Re response to DA 2021/0669 Traffic Management Plan

Request to delete the condition over Shaker Requirement

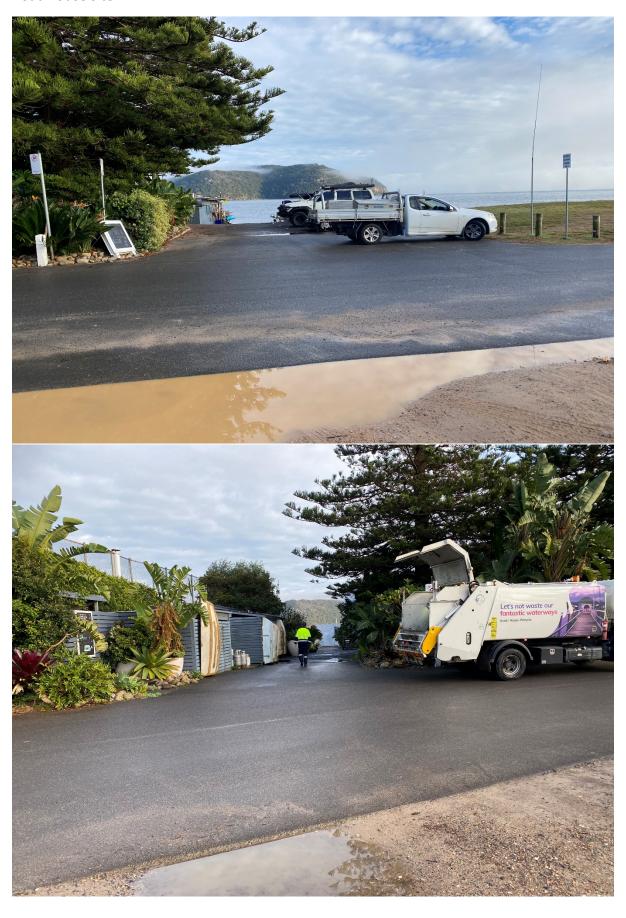
In the response from traffic a requirement for shaker for vehicles was included. We have an issue with this due to its required location to be effective at the entrance to the site. This would require its constrauction in the drip zone and structural root zone of the Tree.

The construction of the shaker would put us at odds with the Arborist. Noting the trees are heritage protected.

The soil on site above MHWM is sand with small humus content in the upper .150mm as identified in the Geotech report and the contaminated lands report. The latter identified soil as VENM material no contaminates. It's proposed to carry out all deliveries and works on the existing hard surfaces being bitumen and concrete. The only equipment that would be directly in sand would be the Excavators and the Piling Rig on the beach. These would all be loaded and unloaded on the existing Boat Ramp and not tracked through the site above MHWM. All vehicles will deliver and operate from hard surface. Vehicles will be inspected for sand before leaving the site and if required broomed down. The site is similar to the Collaroy Beach seawall site where they use existing council hard surface and construction works are on the beach and no shaker.

## Boat House site

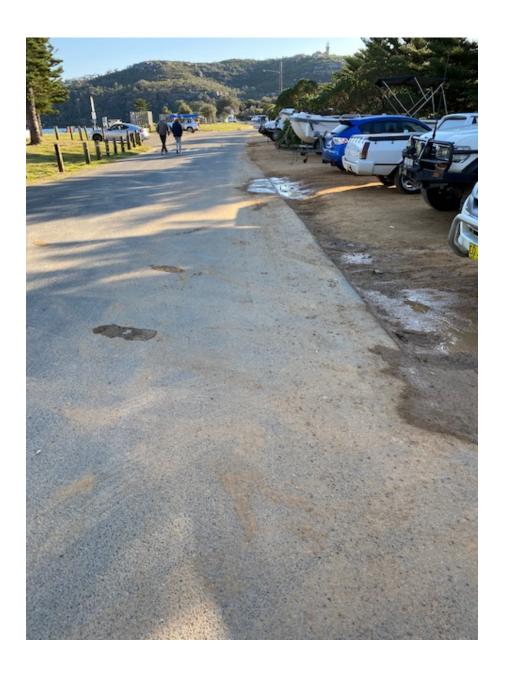
Council Carparking opposite Note not sand but compacted material Photos taken 9/9/21 after rain on 4/9/21. Weather in between sunny
